**TOWN OF LOS GATOS
PLANNING COMMISSION
REPORT**

DATE: November 8, 2024
TO: Planning Commission
FROM: Joel Paulson, Community Development Director
SUBJECT: Requesting Approval for Construction of a Single-Family Residence and Site Improvements Requiring a Grading Permit on a Vacant Property Zoned R-1:8. **Located at 15411 National Avenue.** APN 424-12-140. Architecture and Site Application S-23-033. Categorically Exempt Pursuant to CEQA Guidelines Section 15303: New Construction. Property Owner: Vyankatesh and Rammy Muddada. Applicant: Jose Rama. Project Planner: Erin Walters.

SUBJECT: 15411 National Avenue/S-23-033

RE: 15411 National Avenue

Proposed Front Elevation

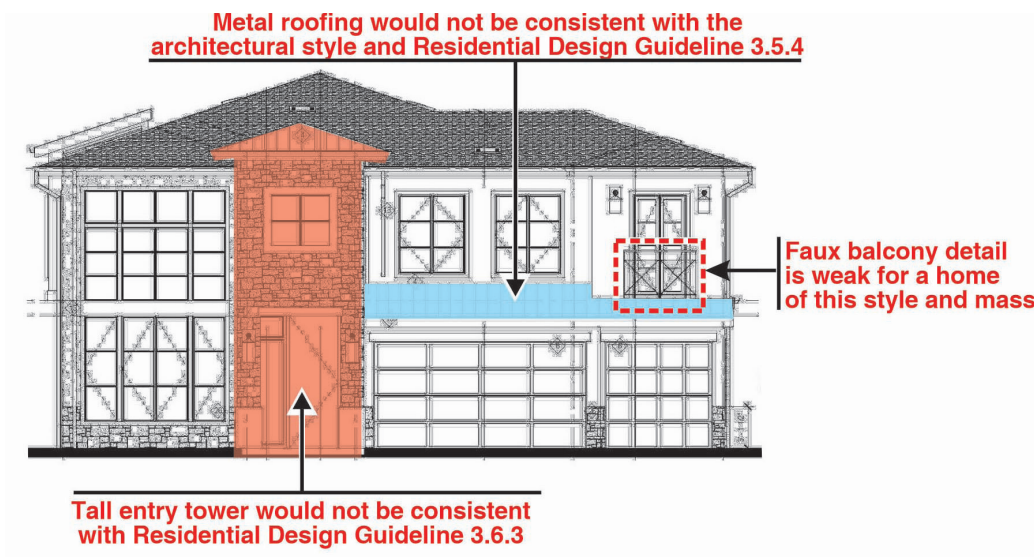
- *Building massing, roof pitches, materials, window types and proportions, design features (e.g., roof dormers), and other architectural features should be consistent with the traditions of the selected style*

Some specific issues include the following:

- *Avoid large and formal entries unless that is the norm for nearby houses. It is often best to start the design consideration with an entry type (e.g., projecting or under eave porch) that is similar to nearby homes.*
2. The proposed metal roofing would not be consistent with the proposed architectural style and Residential Design Guideline 3.6.3.
 3. The faux balcony detail on the front facade is weak for a home of this style and mass.

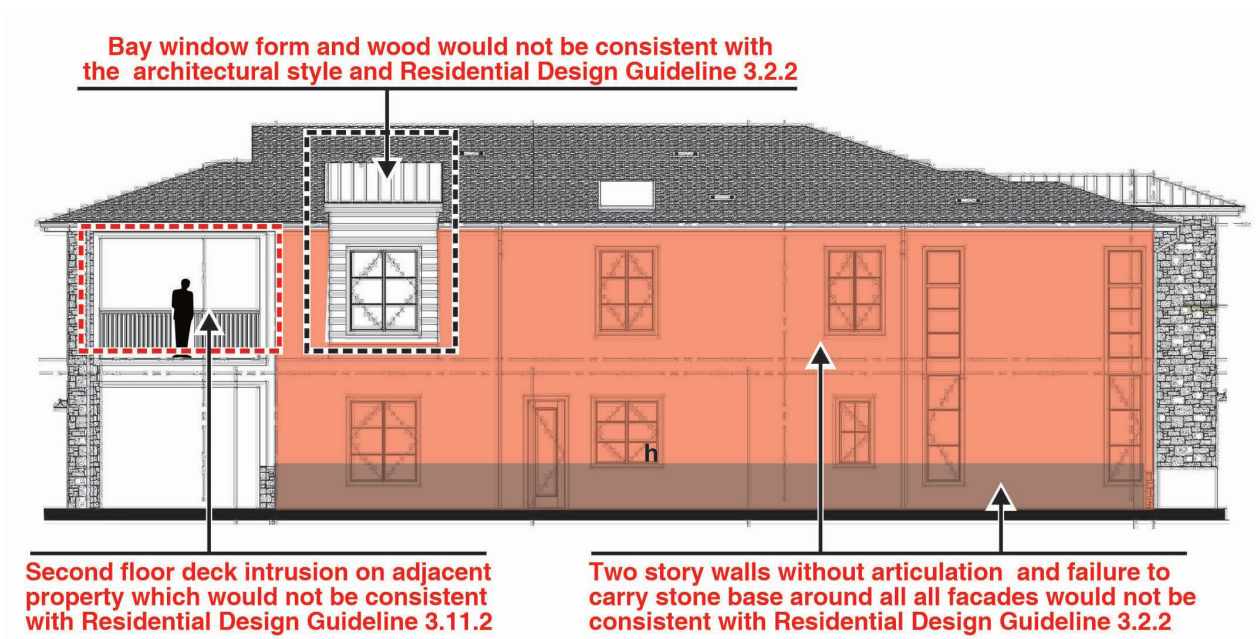
3. The forms and wood siding on the second story bay windows on the side elevations would not be consistent with the architectural style

3.5.4 Design dormers with attention to the architectural style and the neighborhood

3.3.3 Provide visual relief for two story walls

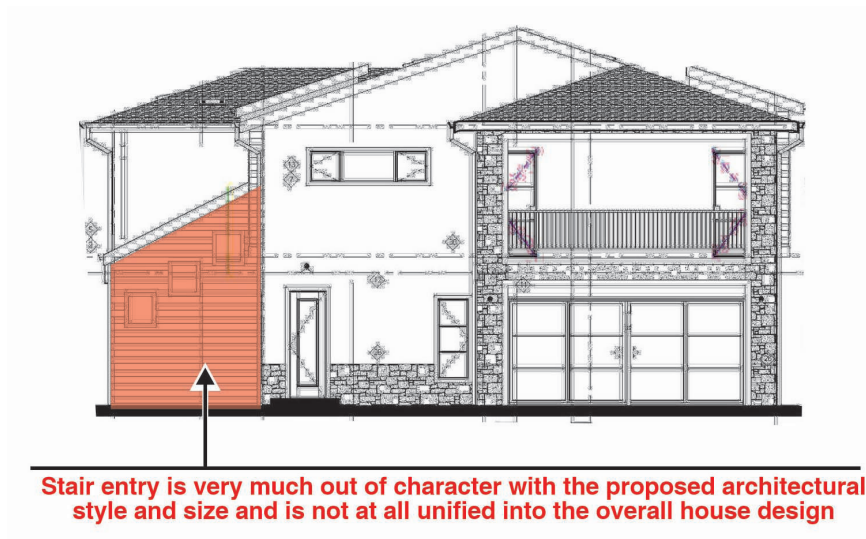
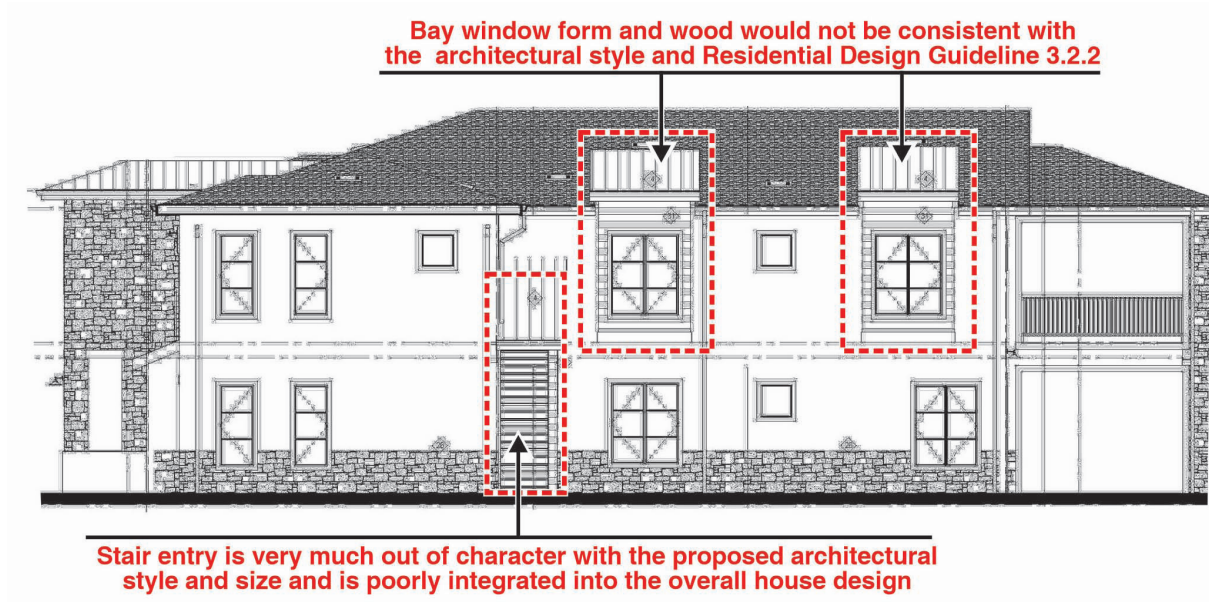
4. The two story wall on the left side facade lacks articulation and would not be consistent with Residential Design Guidelines 3.3.3.

Some techniques include:

- *Belly bands (see photo below left)*
- *Pop outs and bay windows*
- *Material and color changes*
- *Chimneys*
- *Wide overhangs with projecting brackets*
- *Juliet balconies*
- *Window boxes and pot shelves*
- *Landscaped trellises and lattices*

RECOMMENDATIONS

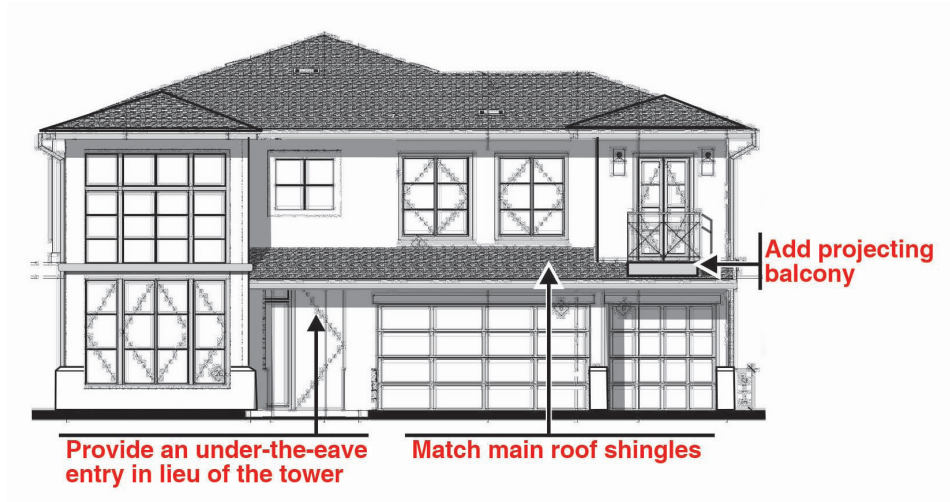
1. Provide an under-the-eave entry in lieu of the proposed stone tower.
2. Match the lower first floor roofing to the shingles on the main roof.
3. Add a projecting balcony at the second floor on the front elevation.

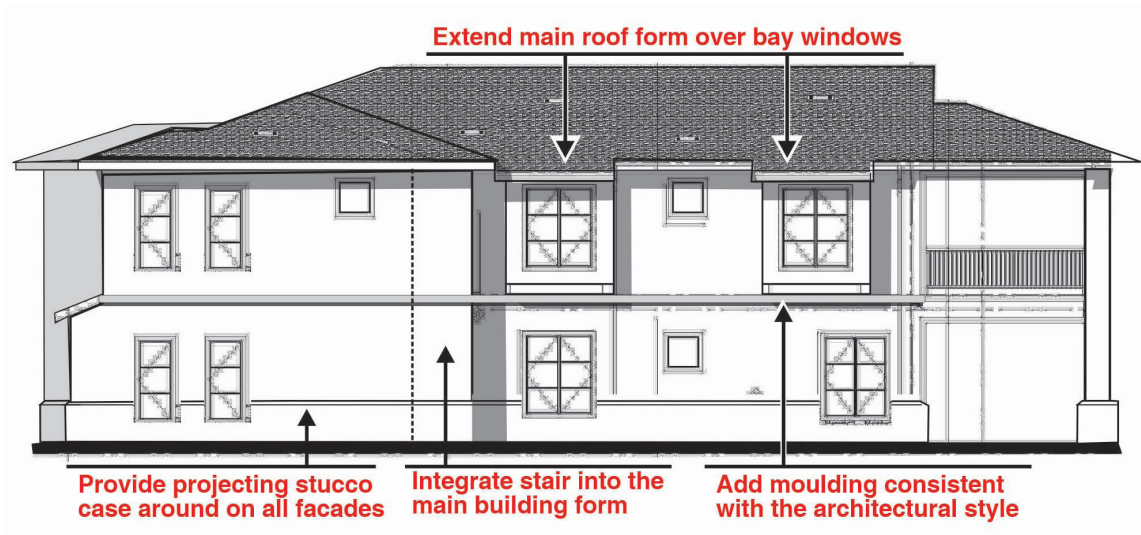
4. Extend the main roof form over the bay windows on the side elevations and use stucco in lieu of the proposed wood siding.
5. Provide projecting trim at the second floor line around all sides of the home.
6. Provide a projecting stucco base around on all facades.
7. Integrate the stair on the right side elevation into the main building form.

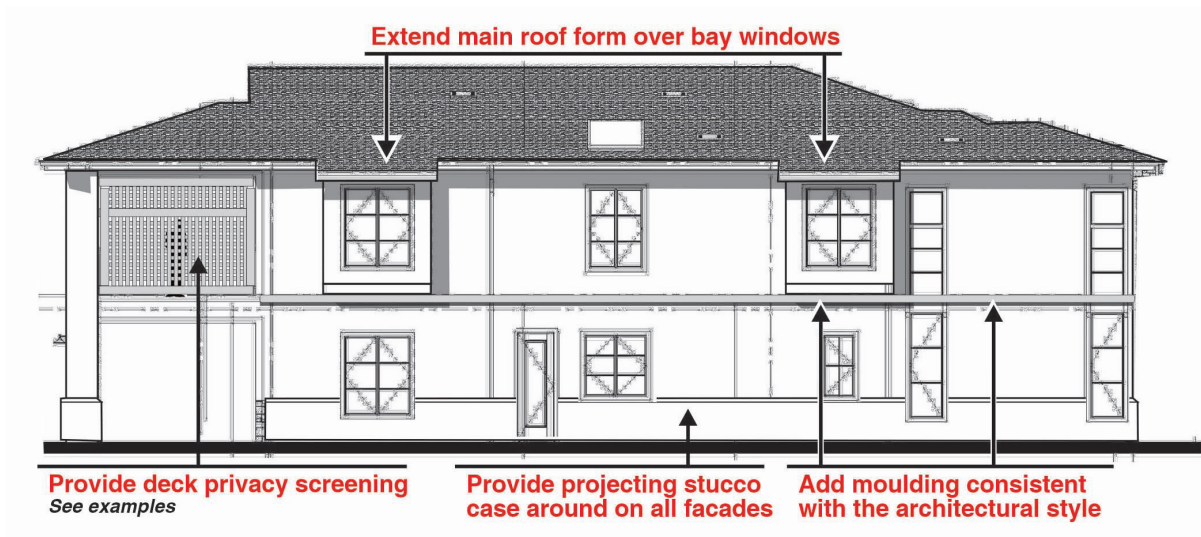
8. Provide a visual screen on the deck side nearest the adjacent property line - some photo examples are shown below.

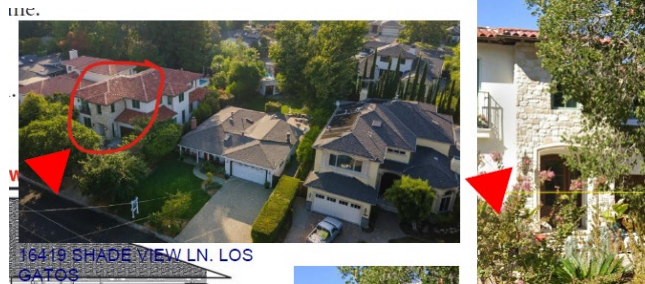
- 1. Provide an under-the-eave entry in lieu of the proposed stone tower.**
REVISED THE ENTRY WAY FROM LARGE TOWER TO SMALLER STONE ENTRY WAY - INVESTIGATED MULTIPLE HOMES IN THE SURROUNDING THAT HAVE BEEN APPROVED BY THE ARCHITECTURAL BOARD, THAT HAVE A STONE TOWER AS AN ENTRY WAY, HAVE PROVIDED PICTURES AND ADDRESS FOR REFERENCE BELOW

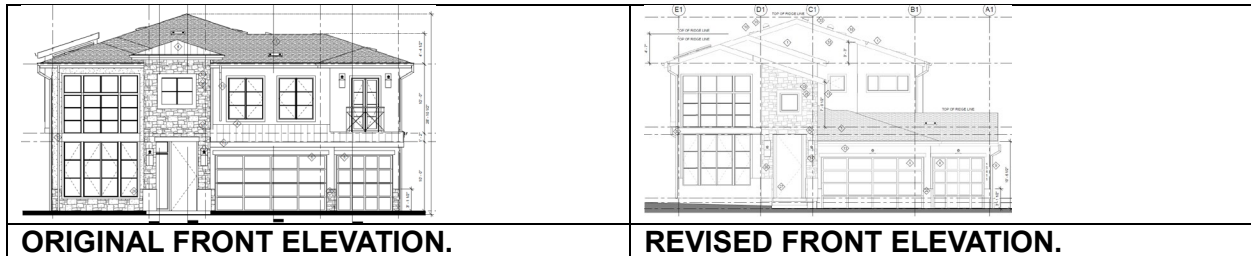
- 3. Add a projecting balcony at the second floor on the front elevation.**
REVISED FRONT ELEVATION BY REMOVING THE JADU FROM THE SECOND FLOOR OVER THE GARAGE, REDUCING THE BULKY DESIGN AND REDESIGNED THE ROOF LINE TO ACCOMMODATE A SMOOTHER TRANSITION.

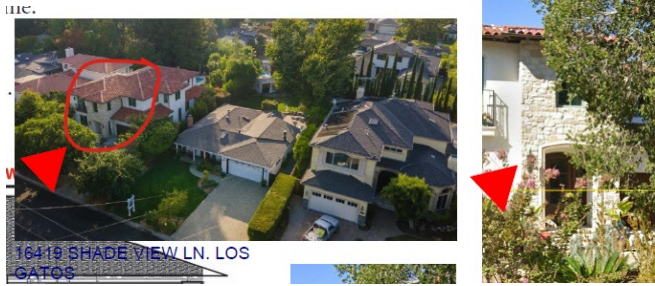
- 4. Extend the main roof form over the bay windows on the side elevations and use stucco in lieu of the proposed wood siding.**

REVISED NORTH ELEVATION BY RELOCATING THE JADU TO THE BASEMENT LEVEL THAT ALSO REDUCES THE MASSING AND BLENDS THE JADU ENTRANCE WITH THE FAÇADE. EXTENDED MAIN ROOF FORM OVER BAY WINDOWS ON SIDE ELEVATIONS AND USE STUCCO IN LIEU OF THE PROPOSED WOOD SIDING. REVISED THE ROOF LINE TO ACCOMMODATE THE EXTENSION OF THE BAY WINDOWS AT ALL LOCATIONS.

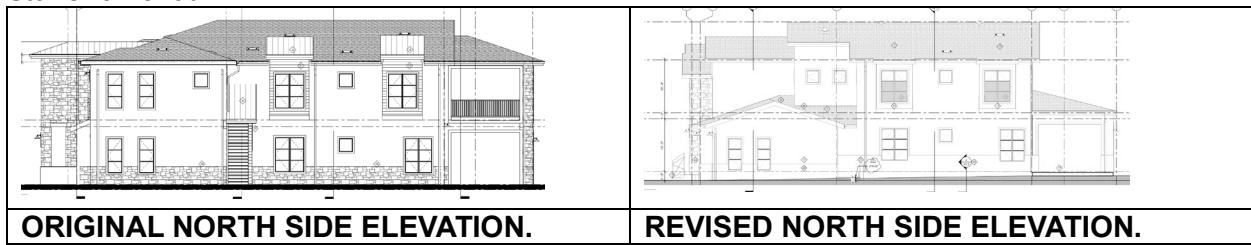
6. Provide a projecting stucco base around on all facades.
REVISED THE BASE TO PROJECT FROM WALL WITH A WAINSCOT PROFILE.

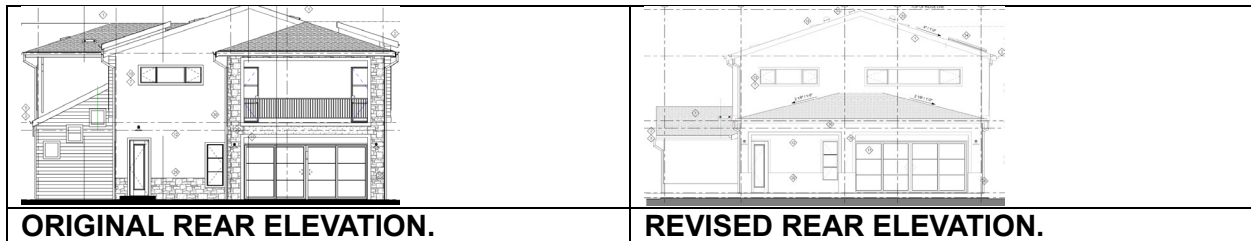
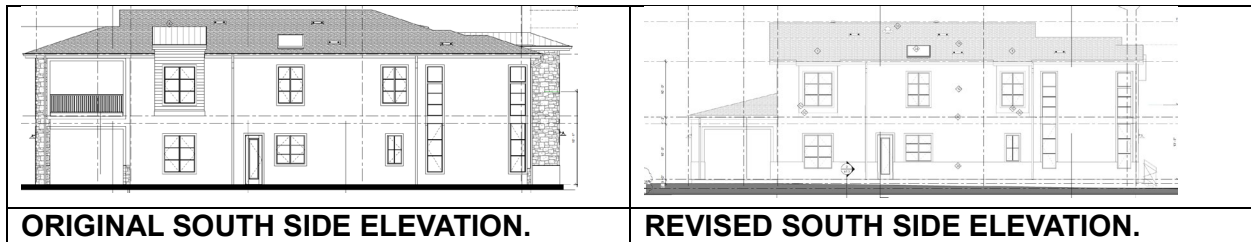
7. Integrate the stair on the right-side elevation into the main building form.
Stairs removed.

8. Provide a visual screen on the deck side nearest the adjacent property line.
SECOND STORY DECK REMOVED TO ADDRESS PRIVACY.
